MCIP ROADWAY IMPROVEMENTS
 TOWN OF ADDISON, TEXAS

TDA NO. 2002-102
 MCIP PROJECT NO. 10305
 ADDISON RD - FROM BELT LINE RD TO ARAPAHO RD

This record drawing is a compilation of the sealed engineering drawing for this project, modified by addenda, change orders and information furnished by the contractor. The information shown on the record drawings that was provided by the contractor or others not associated with the design engineer cannot be verified for accuracy or completeness. The original sealed drawings are the property of the engineer, architects & others, LLC.

REVISION
 ELECTRICAL VOLTAGE CHANGES - OCTOBER 24, 2007

1 ROADWAY LIGHTING - PART B-C

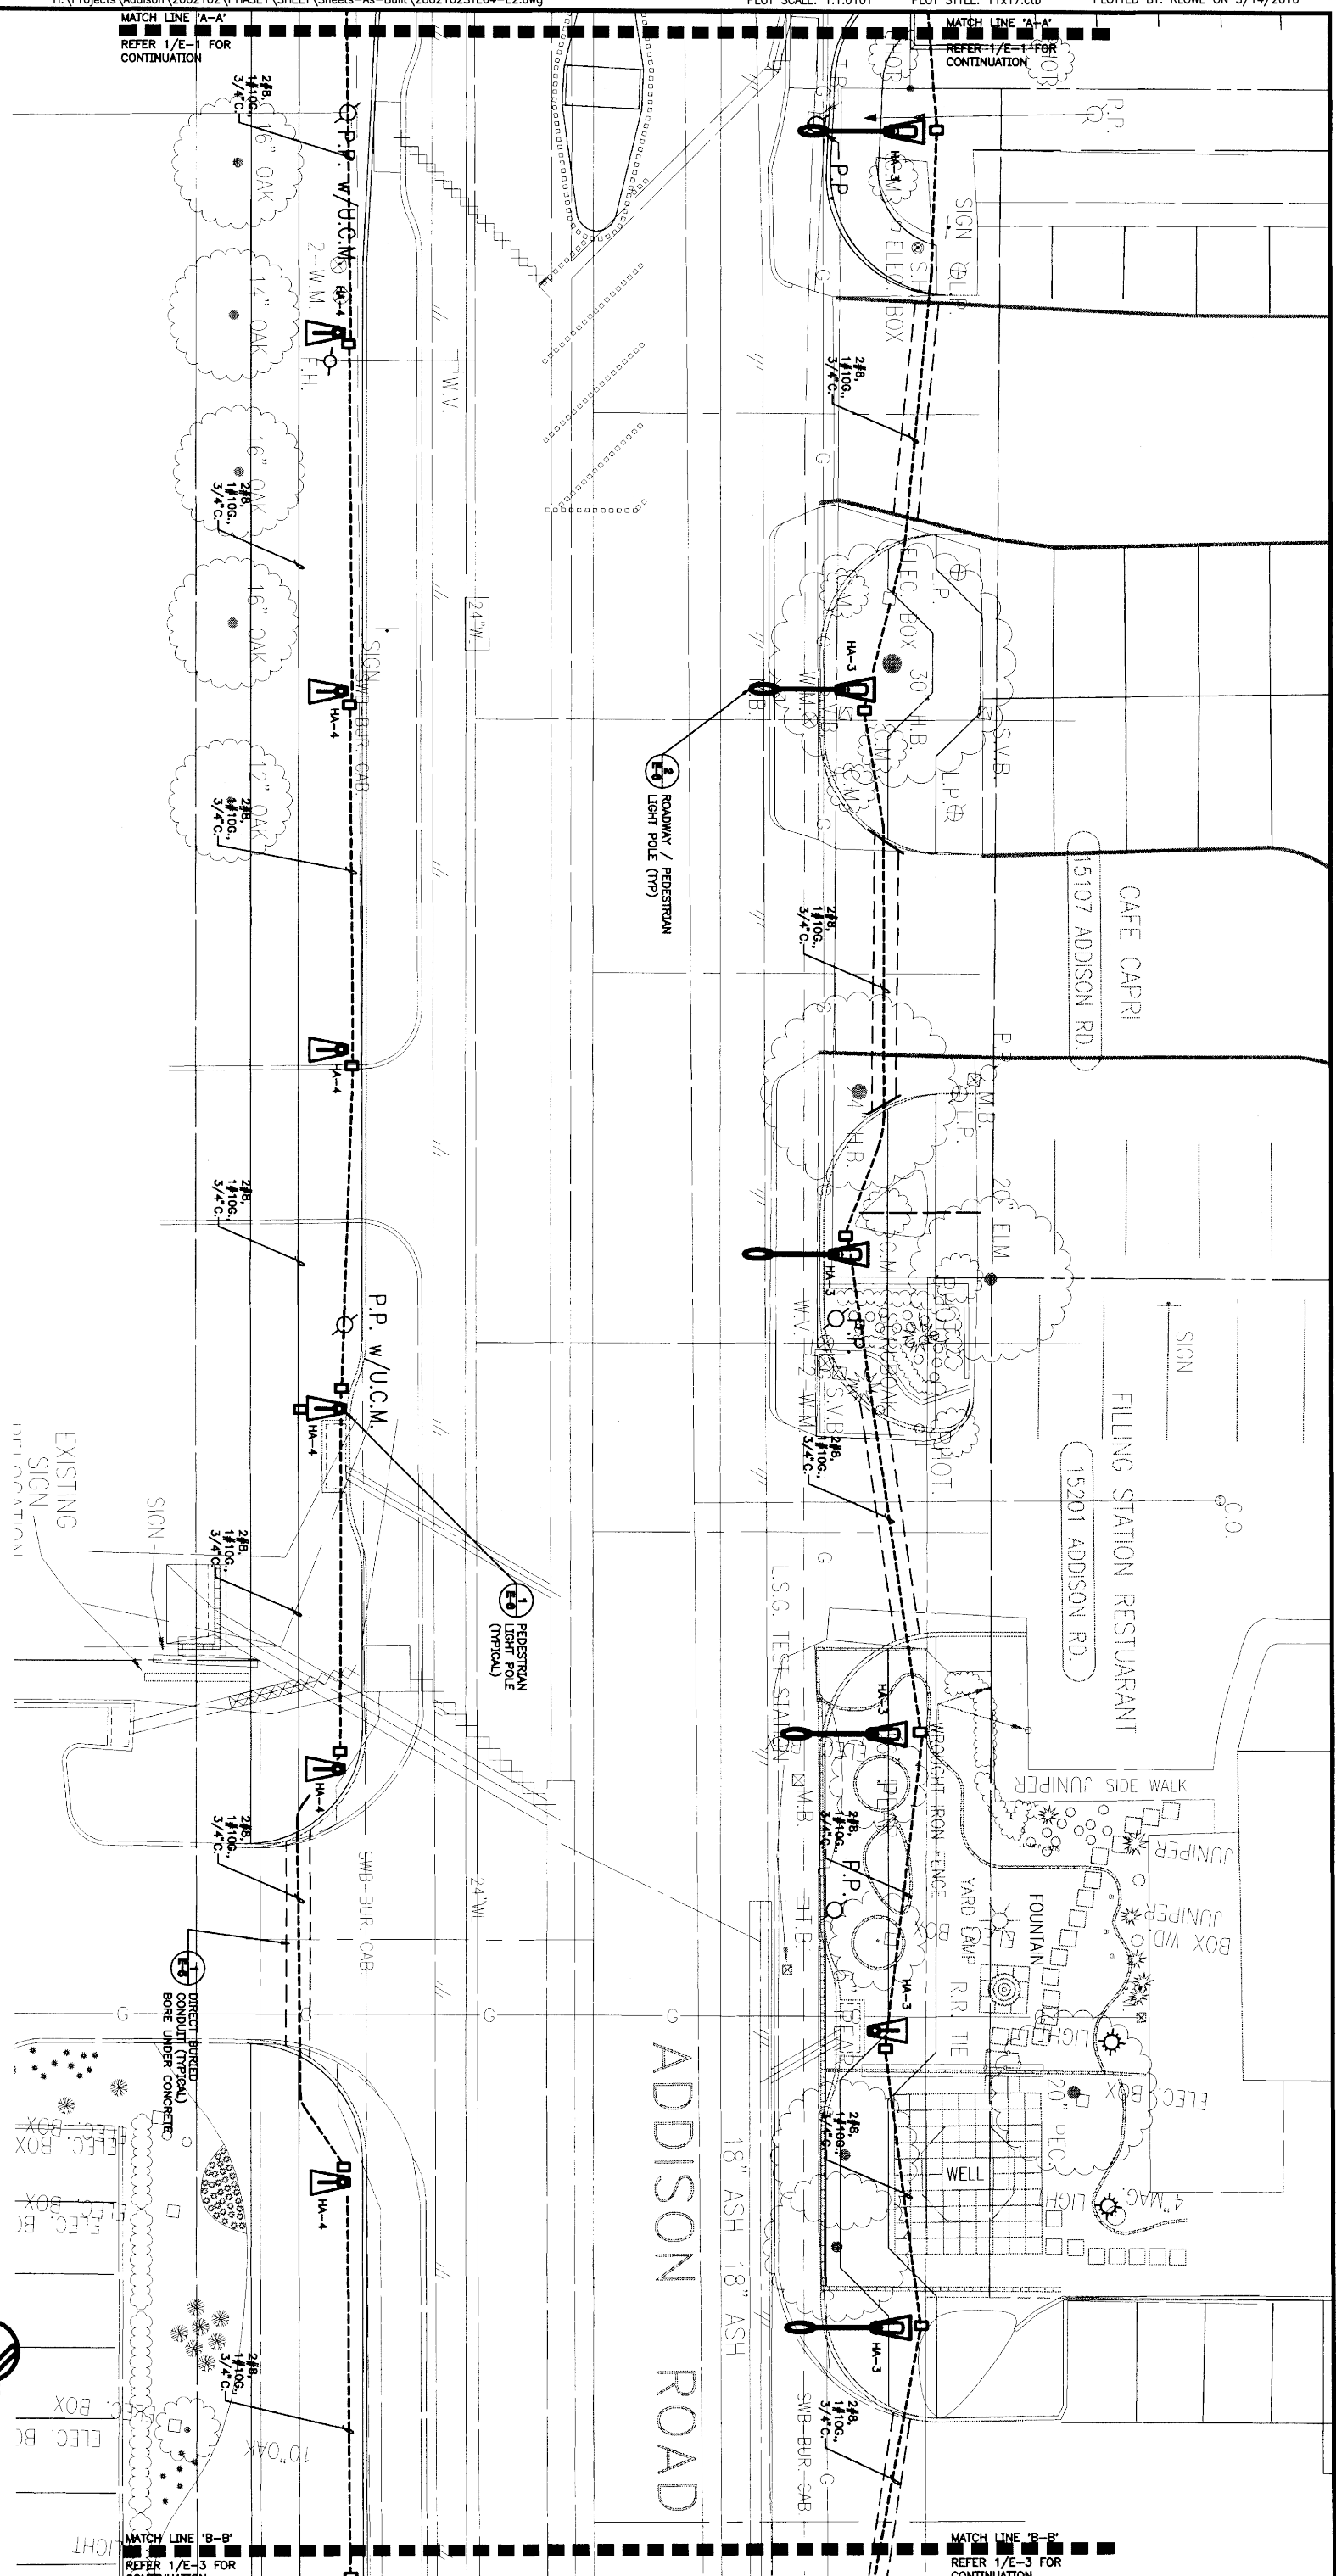
3. Change the conduit size to 2-inch.
- B. Sheet No. 64 (Drawing E-2): Roadway Lighting - Part "B"
 1. Currently a single feeder containing 2 #10, #10G, 3/4" C, is shown from the single service to each pullbox/light fixture. Provide an additional feeder of 2 #10, #10G, 2" C, to also loop through each pull box. One circuit will serve Roadway Lighting exclusively while the other feeder will serve Pedestrian and Irrigation Systems.

2. Change the conduit size to 2-inch.
- C. Sheet No. 65 (Drawing E-3): Roadway Lighting - Part "C"
 1. Currently a single feeder containing 2 #10, #10G, 3/4" C, is shown from the single service to each pullbox/light fixture. Provide an additional feeder of 2 #10, #10G, 2" C, to also loop through each pull box. One circuit will serve Roadway Lighting exclusively while the other feeder will serve Pedestrian and Irrigation Systems.

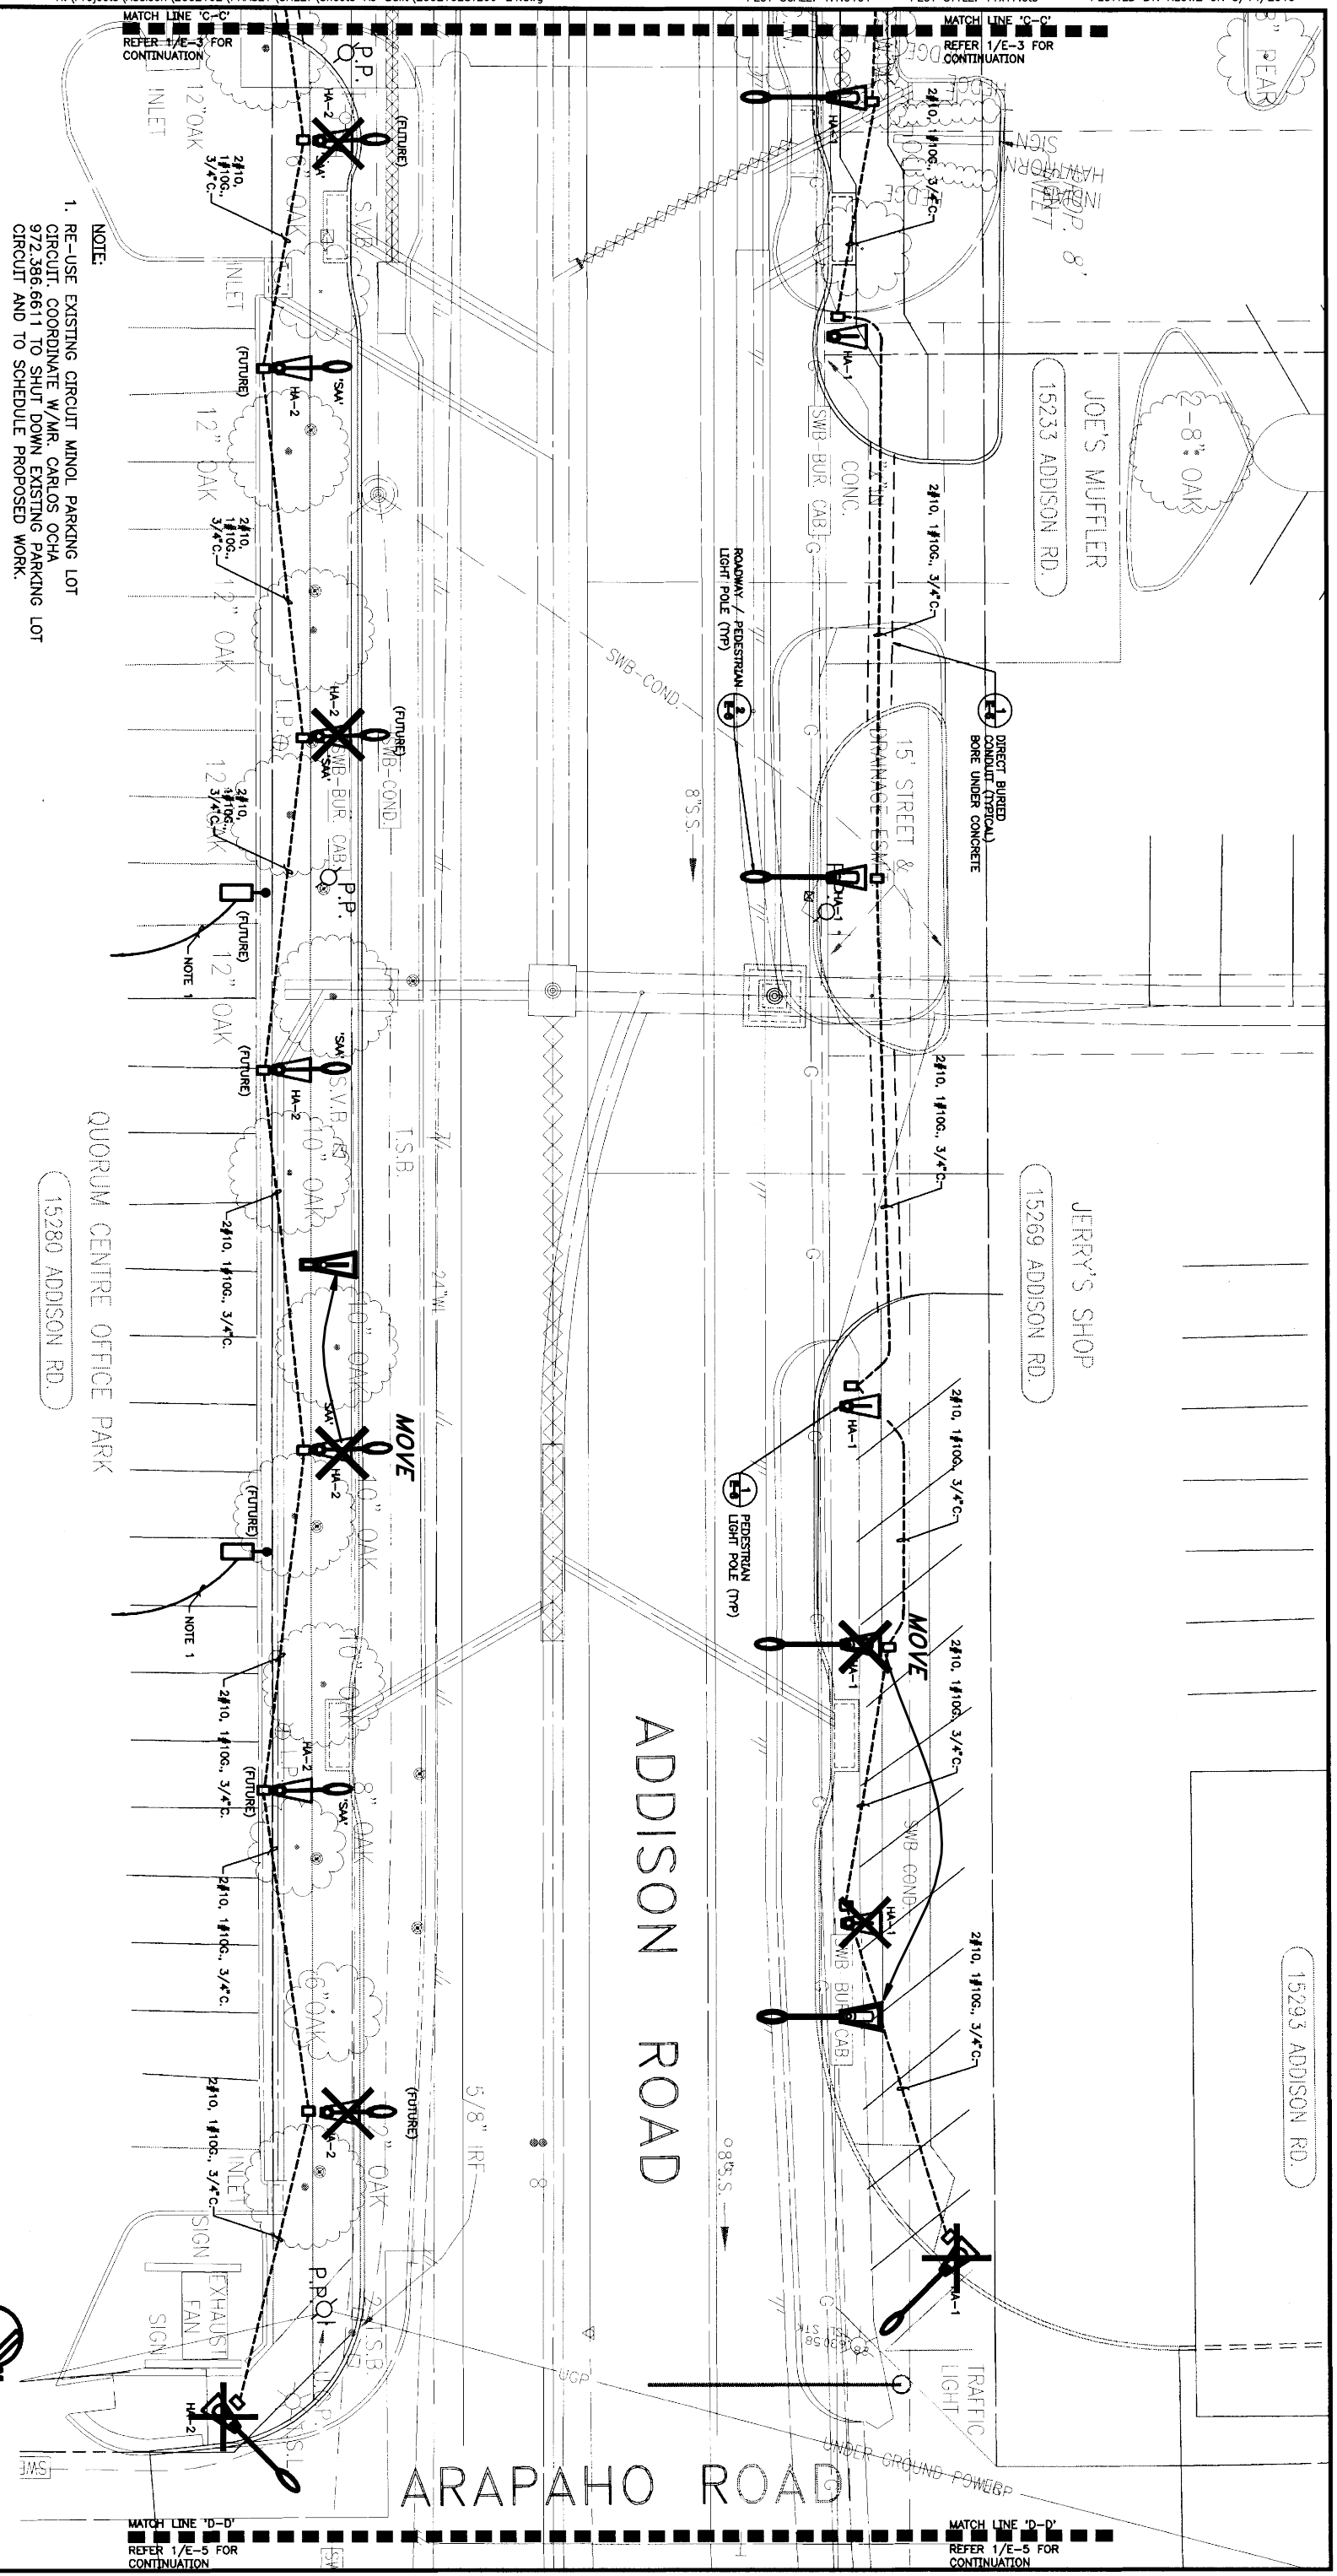
2. Change the conduit size to 2-inch.
- D. Sheet No. 66 (Drawing E-4): Roadway Lighting - Part "D"
 1. Add an additional Utility Service/Detail 2/E-5 for a total of two (2) Utility Services. One service will serve Roadway Lighting exclusively and the other service will serve Pedestrian and Irrigation Systems.

2
ROADWAY/PEDESTRIAN FIXTURE 'SA'
 SCALE: NONE

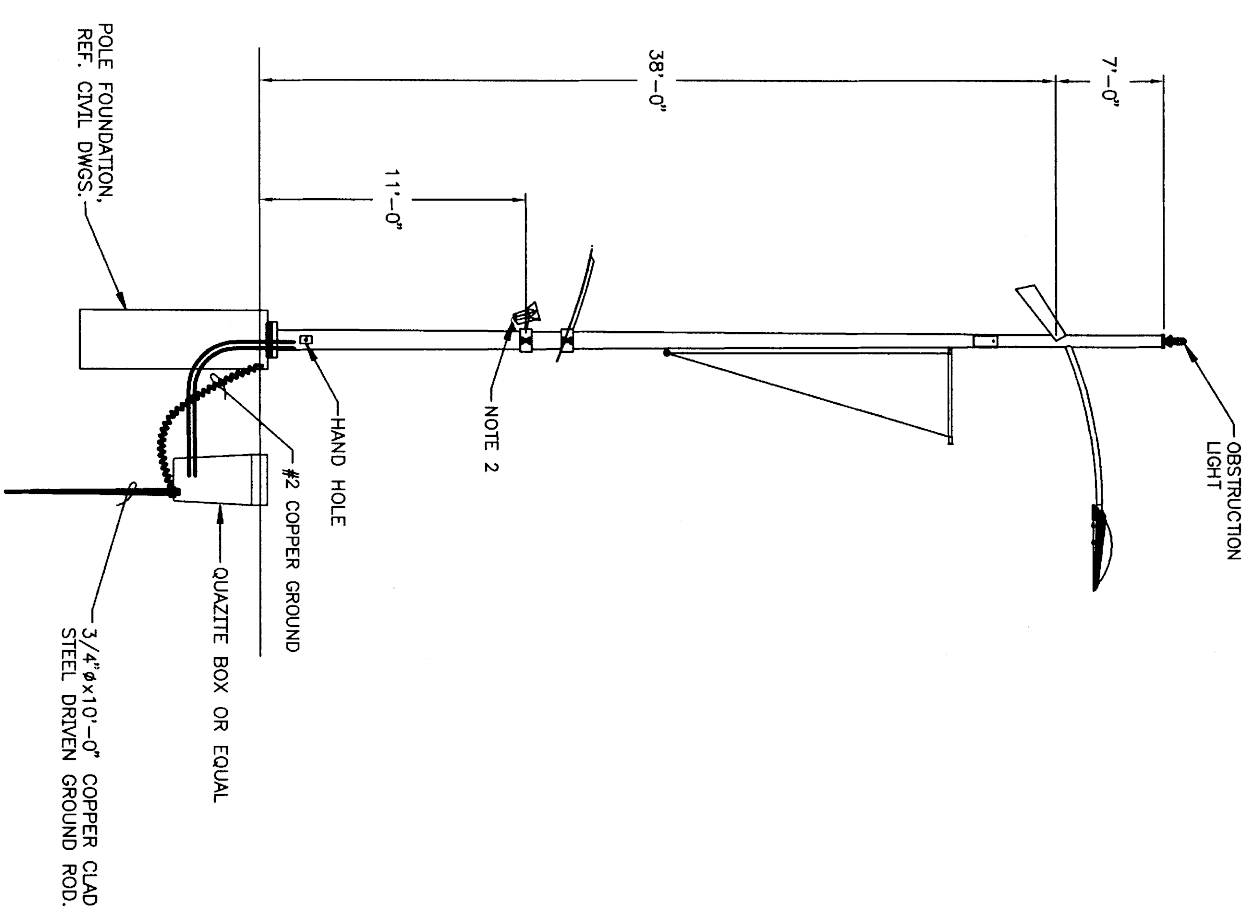
- E. Sheet No. 66 (Drawing E-5): Details.
 1. Modify detail 3/E-5 height currently indicated for the pole as 38'-0" to 17'-0".
 2. Detail (3/E-5) Fixture SAA add the following:
"For combination roadway/pedestrian type SA fixture, the light fixture and obstruction light will both be served from the pedestrian lighting circuit and be controlled by the obstruction light photo cell."

- F. Sheet No. 67 (Drawing E-6):
 1. The roadway light fixture SA will be served from the roadway lighting circuit and be controlled by the photo cell mounted on top of the roadway fixture.
